Florida Power & Light Company
Turkey Point Plant, Units 6 & 7
COL Application

Part 4

Technical Specifications

PLANT SPECIFIC TECHNICAL SPECIFICATIONS (PSTS)

FIGURE 4.1-1 Low Population Zone and Site Boundary Map

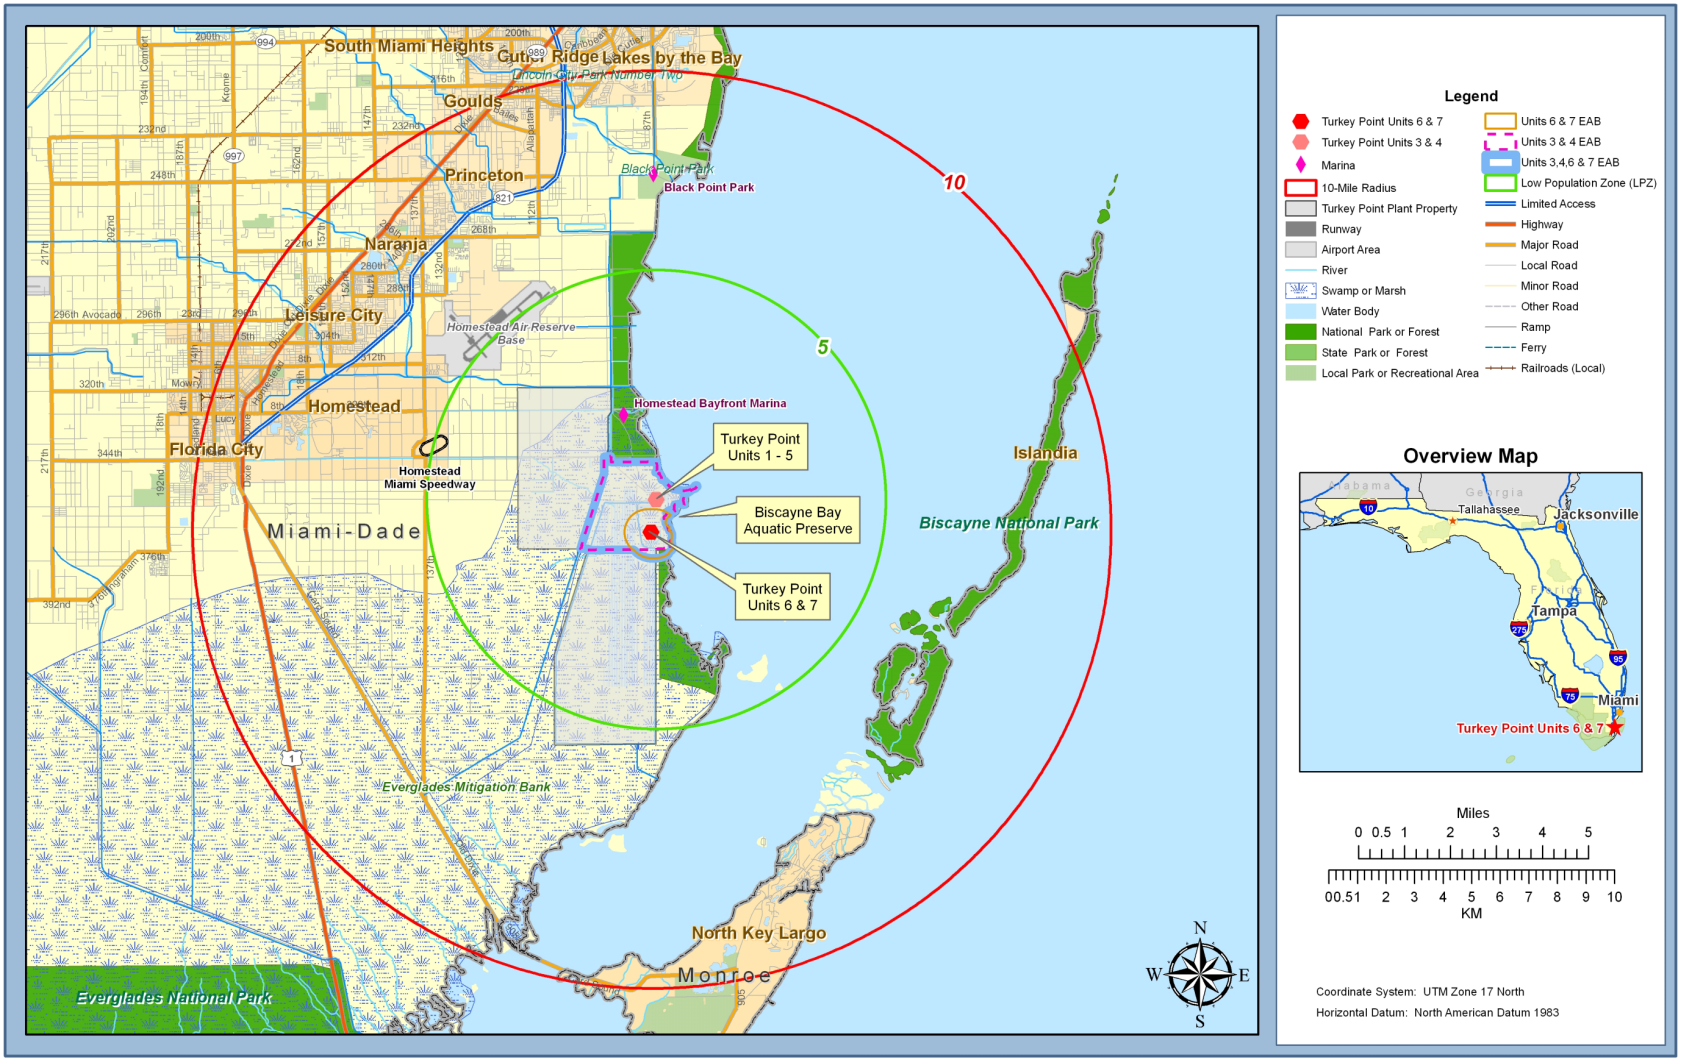
Replace the bracketed information in the GTS with the following:
The Site Boundary is shown in Figure 4.1-1. The Exclusion Area Boundary is shown in Figure 4.1-2.

Replace the bracketed information in the GTS with the following:
The LPZ is defined by the 5 mile radius from the site center point as shown in Figure 4.1-1.
